City of Mt. Vernon Planning and Zoning Commission January 22, 2025 6:30 PM City Hall, 213 1st Street NW

AGENDA ITEM #7: Site Plan Review – Kwik Star

Dave Schechinger of Veenstra & Kimm, Inc. has reviewed the December 23, 2024 site plan, drainage report and construction drawings and provided the following comments:

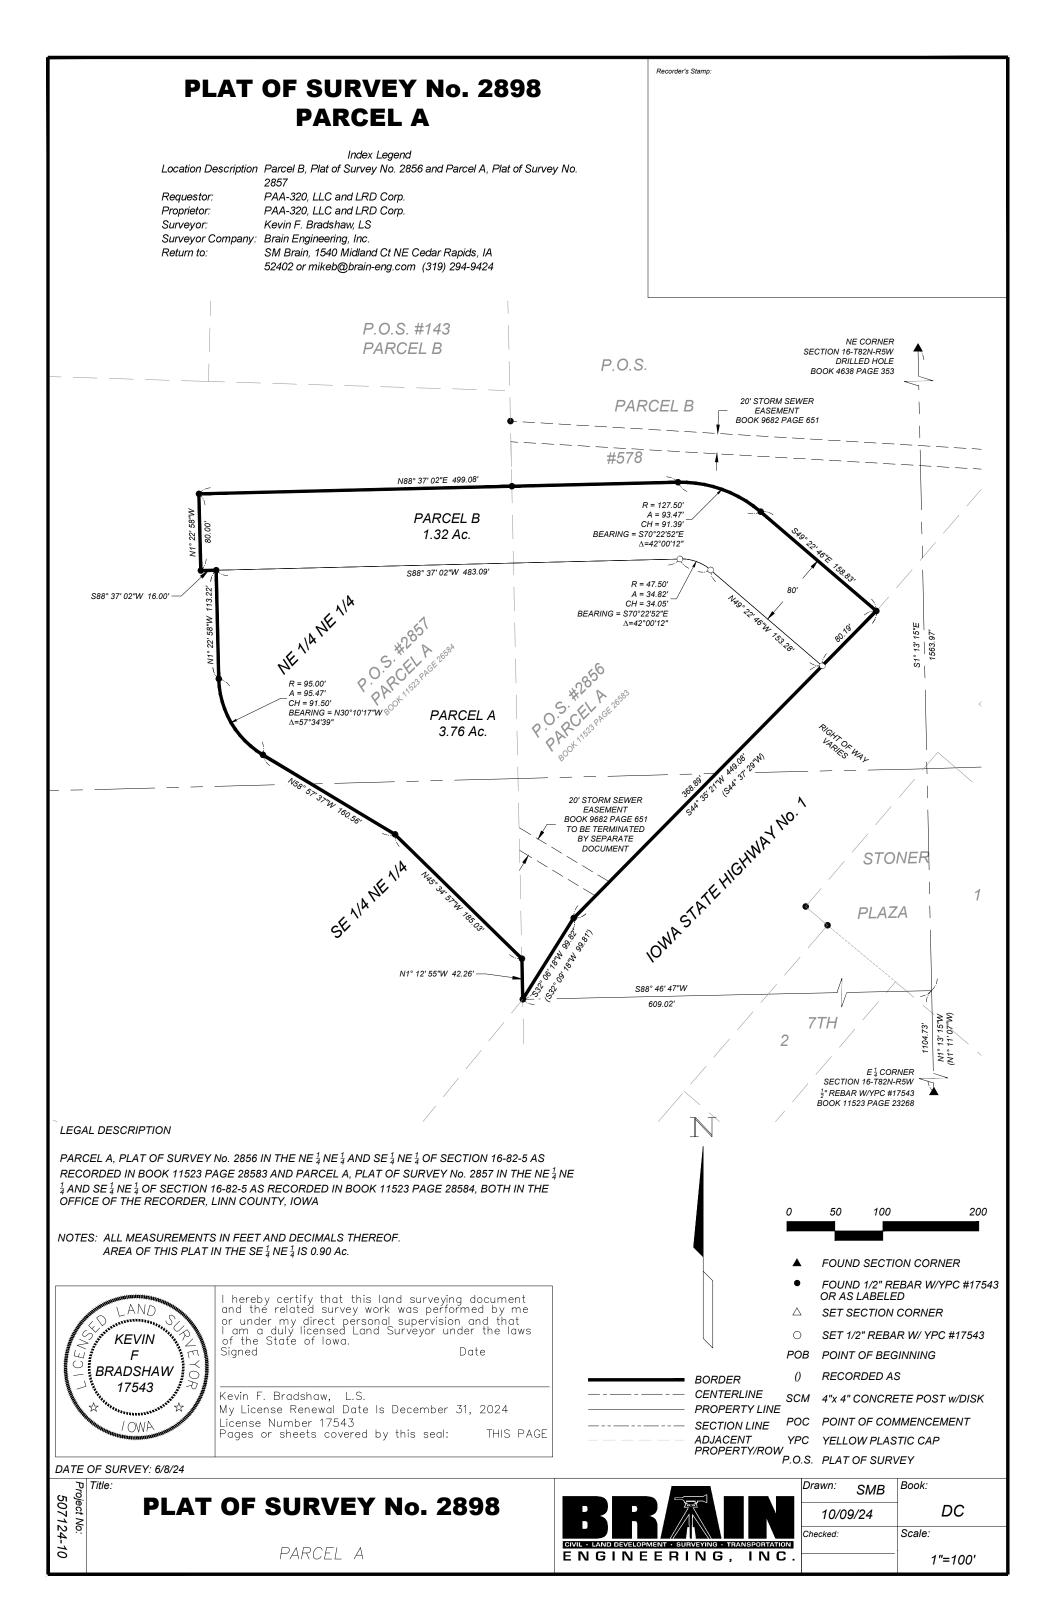
Analysis: City Council approved Plats #2856 & 2857 in August, 2024. City Engineer Dave Schechinger is working with current and proposed owners, to establish the location of permanent stormwater and public utility easements. Parcel B will be dedicated as public right-of-way (ROW) for westward extension of Rachel Street.

Both engineering and legal counsel will need to approve the easement and dedication notation prior to final approval of the Plat by City Council.

Staff Recommendation: Recommend approval of site plan, subject to review and approval by engineering and legal of the following items:

- Public utility and storm water easement location & elevations
- Dedication of Parcel B for Rachel Street ROW
